## **MVC Questions/Concerns**

Edgartown-Vineyard Haven Road at Barnes Road and Airport Road, Oak Bluffs, Massachusetts

## Negligible Change to traffic in VH & Edgartown

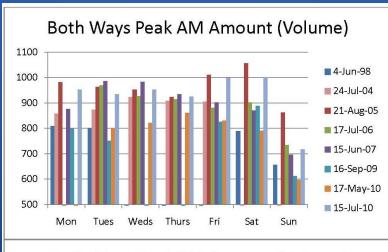
Will relieving congestion at the Blinker lead to additional traffic at the ends? *If the overall volume on the ED-VH Road remains the same?*

- One (1) additional vehicle approximately every 4-5 minutes EB 4+ miles away
- One (1) additional vehicle approximately every 12 minutes WB 2+ miles away

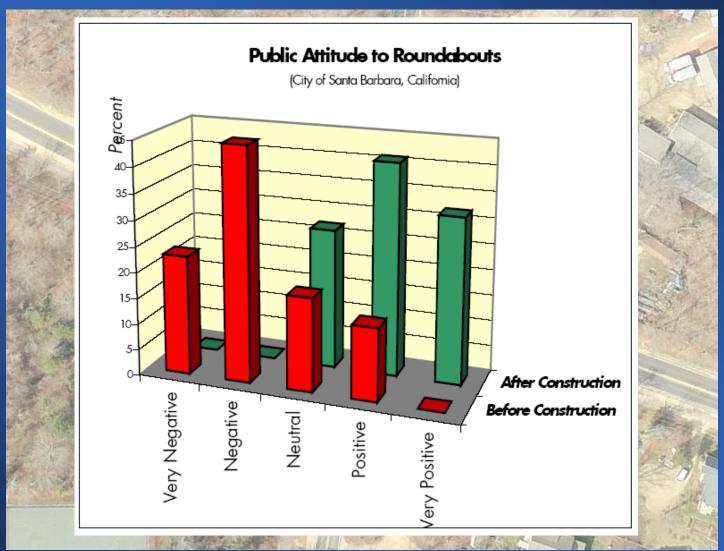
#### What would happen if the pull-offs were not built as part of this proposal?

Typically there would be a 5 yr period where the newly constructed road surface could not be altered – unless for emergency repairs.
